City of Palo Alto

City Council Staff Report

Summary Title: Appeal of Approval Verizon Wireless Small Cell Antenna (Cluster I)

Title: PUBLIC HEARING / QUASI-JUDICIAL: The City Council Will Consider Appeals of the Planning and Community Environment Director's Decision to Approve Eleven (11) Tier 3 Wireless Communication Facility Permits to Establish Small Cell Wireless Communication Antennas and Equipment on Utility Poles in the Public Right of Way Near the Following Addresses: Node #129: CPAU Pole# 3121 (near 2490 Louis Road APN 127-30-062), Node #130: CPAU Pole #2461 (near 2802 Louis Road APN 127-28-046), Node #131: CPAU Pole #3315 (near 891 Elbridge Way APN 127-26-067), Node #133E: CPAU Pole #2856 (near 949 Loma Verde APN 127-24-020), Node #134: CPAU Pole #2964 (near 3409 Kenneth Dr APN 127-09-028), Node #135: CPAU Pole # 3610 (near 795 Stone Ln APN 127-47-001), Node #137: CPAU Pole #3351 (near 3090 Ross Rd APN 127-52-031), Node #138: CPAU Pole #2479 (near 836 Colorado Av APN 127-27-063), Node #143: CPAU Pole #3867 (near 419 El Verano Av APN 132-15-017), Node #144: CPAU Pole #1506 (near 201 Loma Verde Av APN 132-48-015), Node #145: CPAU Pole #3288 (near 737 Loma Verde Av APN 12

Zoom of Palo Alto Shallow Groundwater Map:

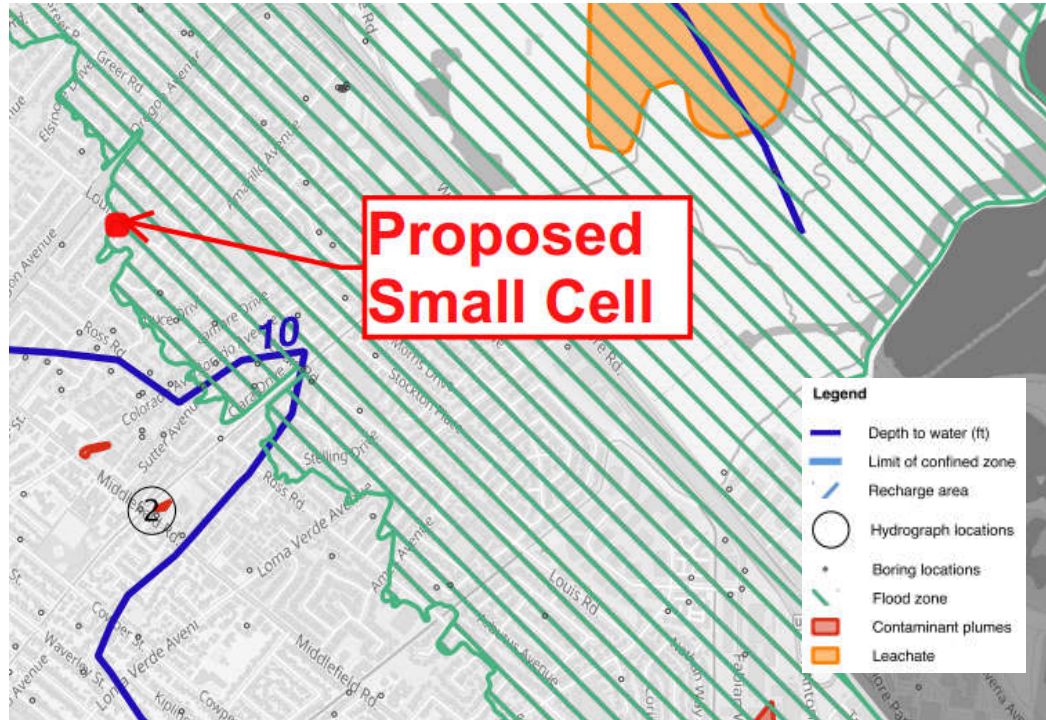
The proposed primary pole lies within the Flood Zone, designated by the green lines.

Palo Alto Shallow Zoom of Palo Alto Shallow Groundwater Map:

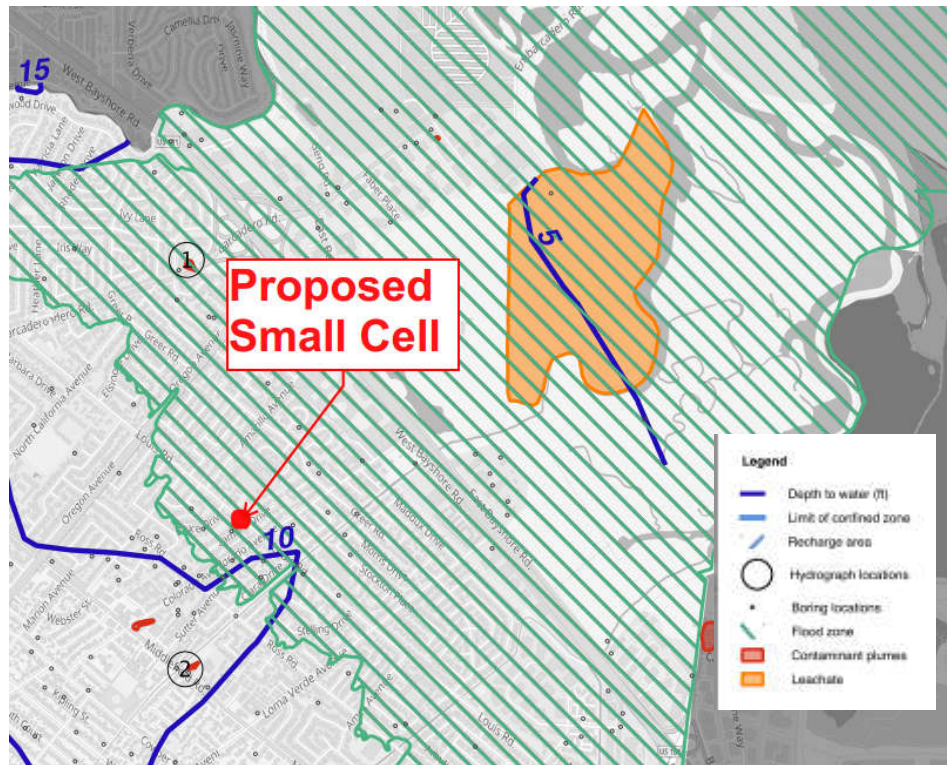
The proposed primary pole lies within the Flood Zone, designated by the green lines.

Photo 1: Primary pole located along SCVWD Storm Drain Channel

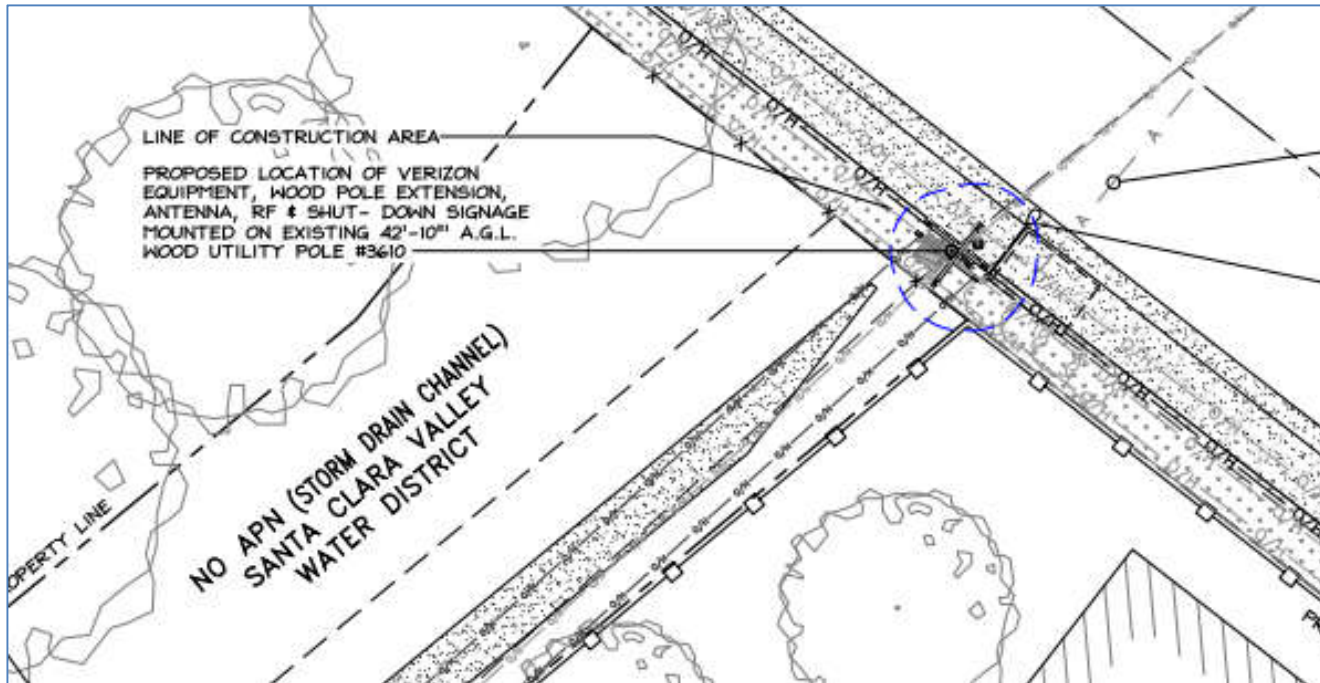
4. The sidewalk along Stone Lane in this area has an excessive slope and rolled curb (see Photo 2). Vaults must be located outside the transition slope and on a level plane per City of Palo Alto Department of Public Works' comment #B16 dated Jan. 2018.
5. Vaults sump pump requires tubes that discharge water into the street; these tubes cannot be placed in a rolled curb, as it creates a trip hazard.

Photo 2: Excessive sidewalk slope and rolled curb, which does not allow for vault placement.

Photo 1: Excessive sidewalk slope and rolled curb does not allow for vault placement.

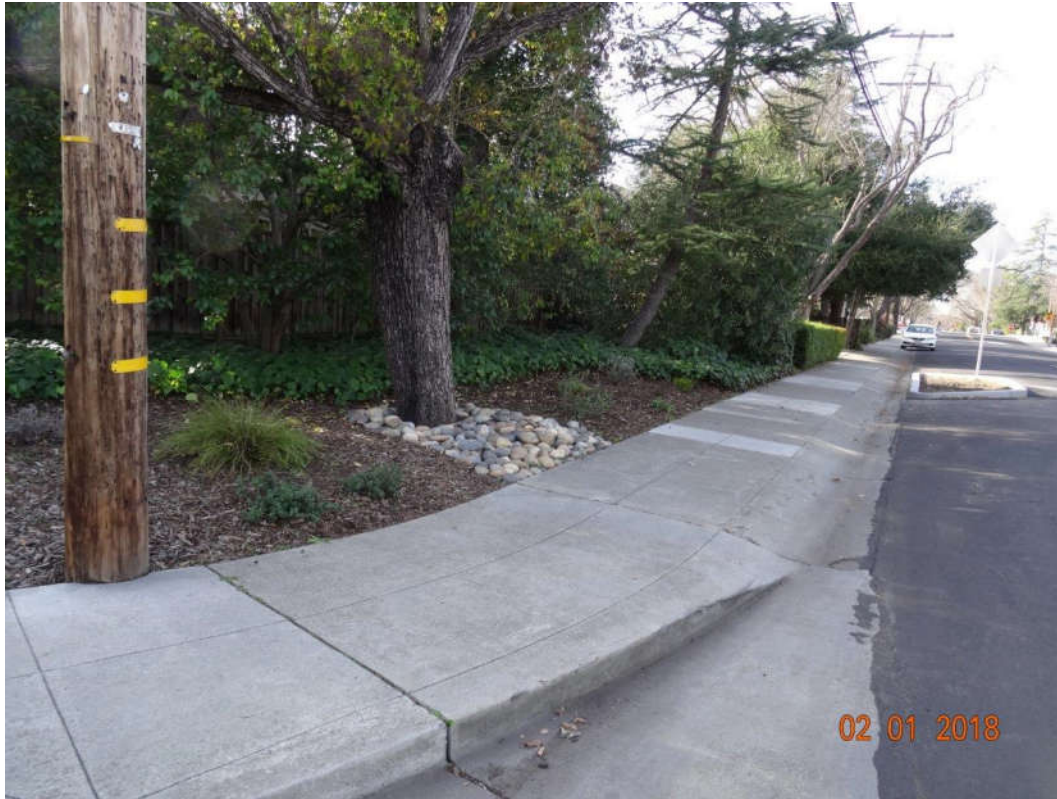
1. Vault must maintain a 5' setback from the selected utility pole per CPAU.
2. The sidewalk along Stone Lane in this area has an excessive slope and rolled curb (see Photo 1). Vaults must be located outside the transition slope and on a level plane per City of Palo Alto Department of Public Works comment #B16 dated Jan. 2018.

Zoom of Palo Alto Shallow Groundwater Map:

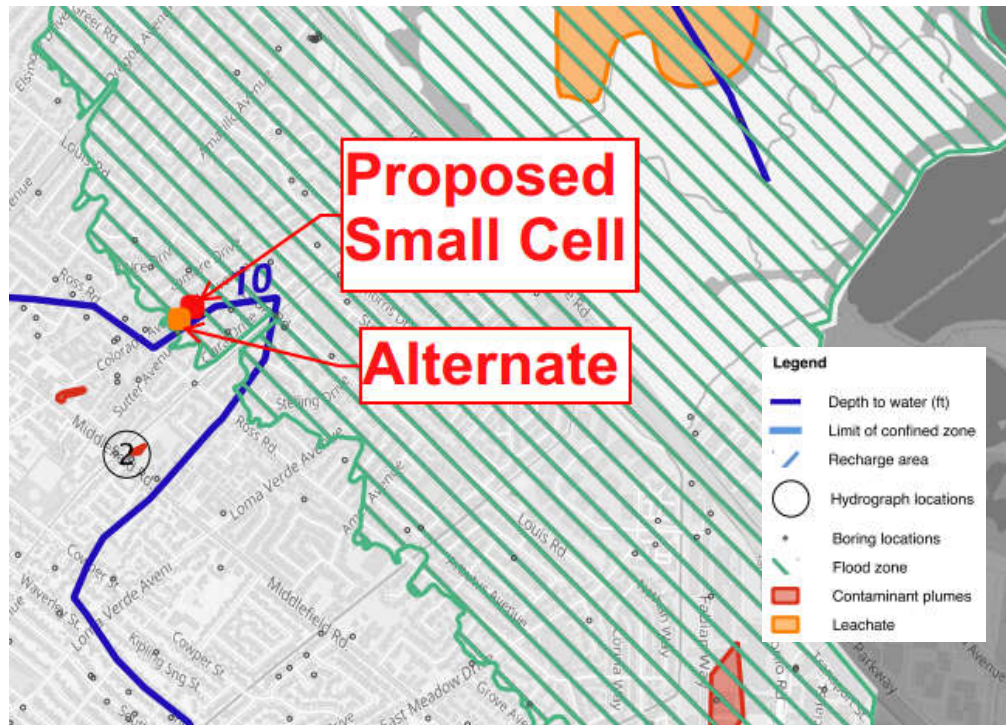
The proposed primary pole, as well as the alternate, both lie within the Flood Zone, designated by the green lines.

Utility Map 1: Laterals servicing the adjacent apartment building run along the entire length of adjacent sidewalk.

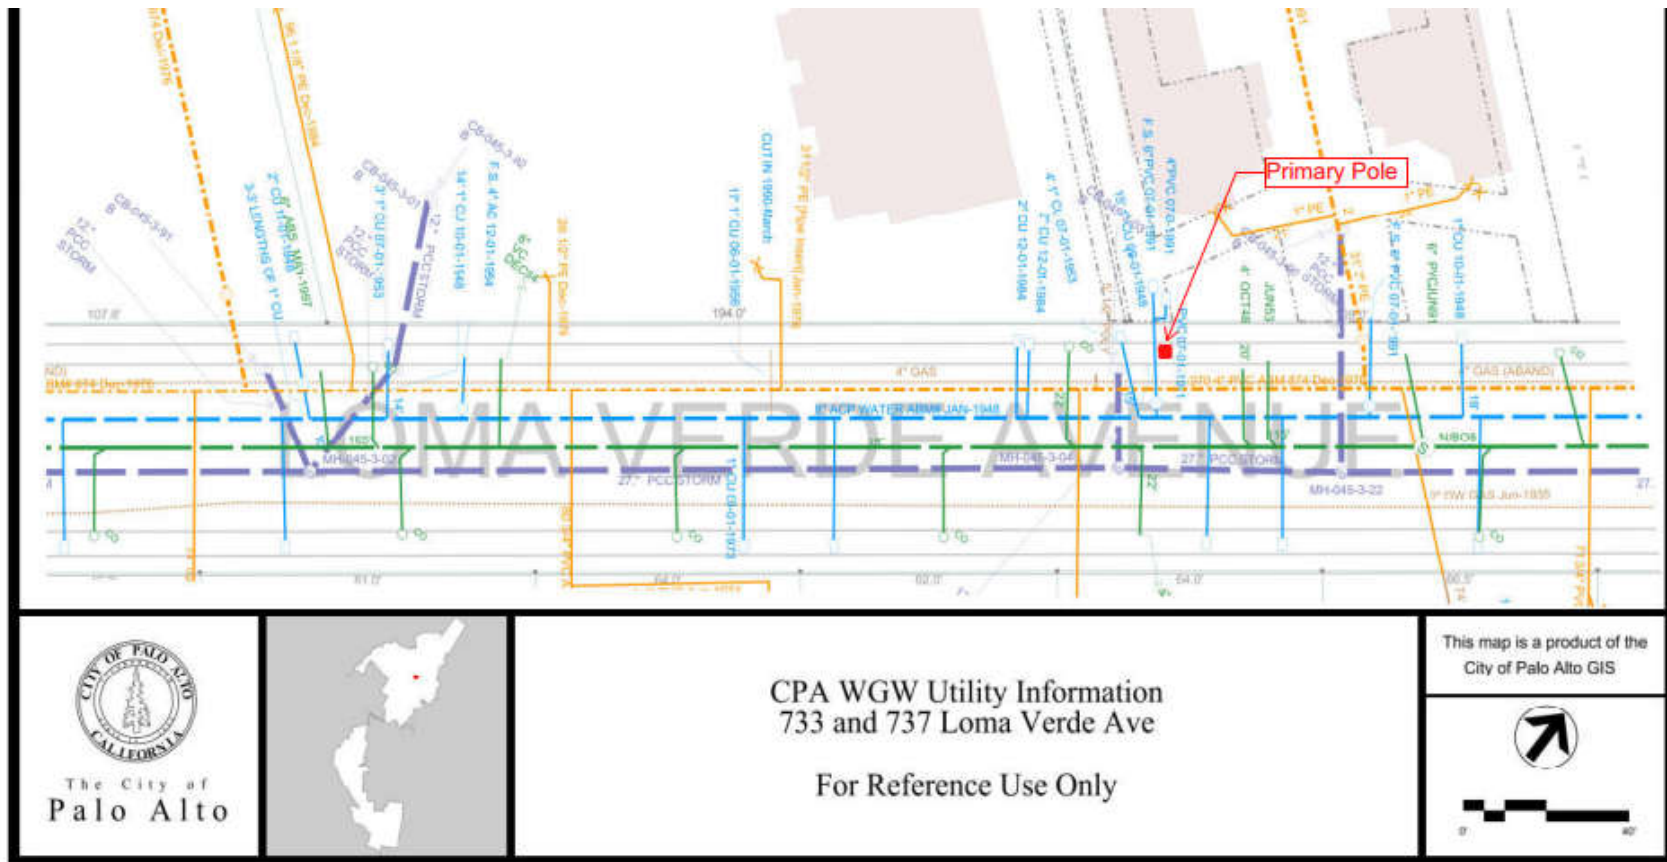
Photo 1: Existing utilities impede vault placement.
